Turf Lea Farm, Turf Lea Road, Marple

Client	Mr & Mrs Copeland	Project	Pool & gym extension	Scale	1:100	Rev no	1	Date	
Location	Turf Lea Farm, Turf Lea Road, Marple SK6 7EZ	Issued for		Sheet size	A1	A01.7C	C	10/02/23

2 SW Elevation proposed

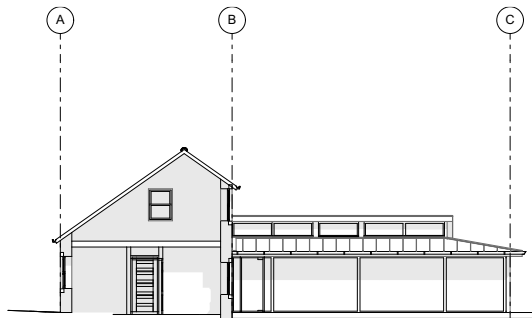
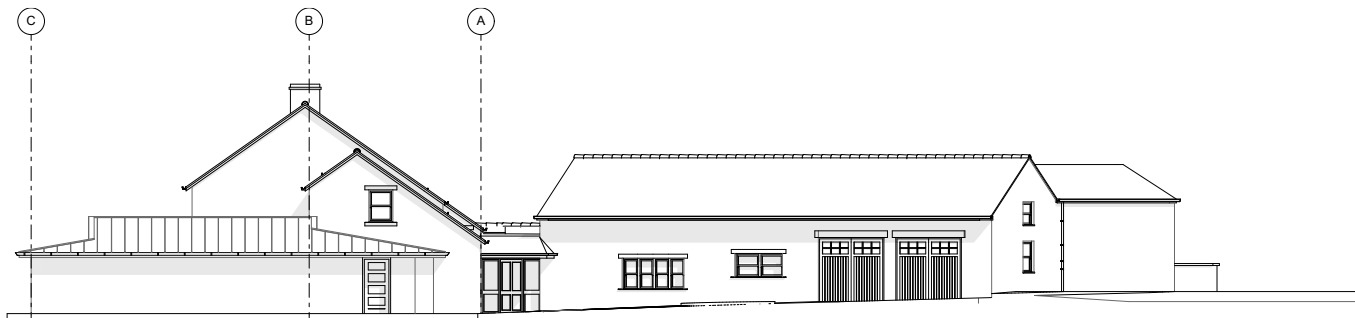
Rev C: 26/06/2020  
Elevations updated to suit client requirements  
Rev B: 23/06/2020  
SW & NE elevations amended to illustrate a reduction in proposed length between gridline B & C of an additional 0.94m, reducing the proposal by a further 26m³ in volume (cross sectional area shaded pink = 27.7m²)  
Rev A: 10/02/2020  
SW & NE elevations amended to illustrate a reduction in proposed length between gridline B & C of 750mm. This reduced length creates a proposed volume reduction of 18.7m³, thereby reducing the submitted proposed volume from 402.7m³ to 384.0m³, as compared to the existing volume of 399.5m³ which is 5.5m³ larger than this amended proposal.
